**RE: RESPONSE TO ASSESSMENT REPORT FOR DEVELOPMENT APPLICATION (DA)  
16/0994 (JRPP: 2016SYE087) FOR DEVELOPMENT AT 31-39 STURT ROAD, AND 2-4 & 2A  
LOCKSLEY STREET, CRONULLA**

### **RESPONSE TO SUTHERLAND SHIRE COUNCIL'S ASSESSMENT REPORT TO THE JOINT REGIONAL PLANNING PANEL (JRPP) FOR THE PROPOSED EXTENSIONS TO THE EXISTING RESIDENTIAL AGED CARE FACILITY AT 31-37 STURT ROAD, CRONULLA**

**ANNEXURE A: SWEEP PATHS (SHEET 2 OF 6)**

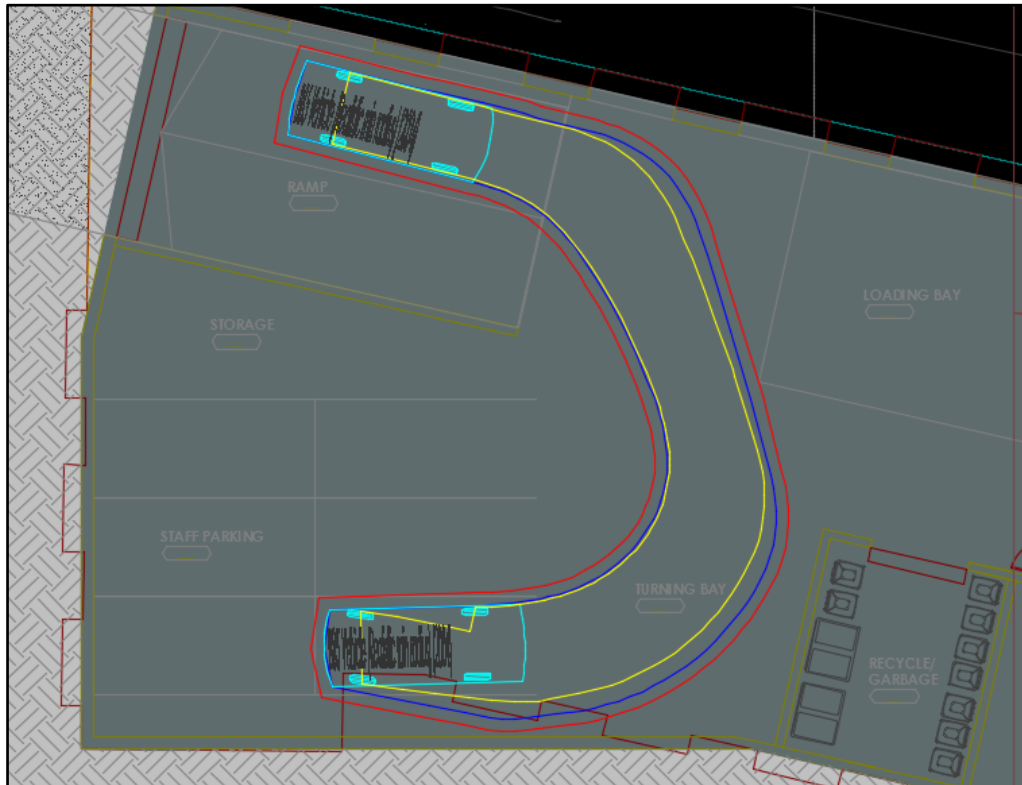
*"The proposed vehicle manoeuvring within the northern and southern basement levels will require excessive turns to access the parking spaces and should not be supported given that this is a new facility able to be designed to achieve acceptable manoeuvring."*

The car parking spaces are for staff only, representing low turnover parking. The manoeuvring of up to 5 points is considered acceptable in this instance as the minor inconvenience is accepted by staff vehicles only and does not result in congestion or safety issues due to the small size of the car parking areas and the low turnover of car parking spaces.

**B85 Entry & Exit (Space 3 & 4) of southern car park  
3 manoeuvres entry; 2 manoeuvres exit  
5km/h  
Successful**
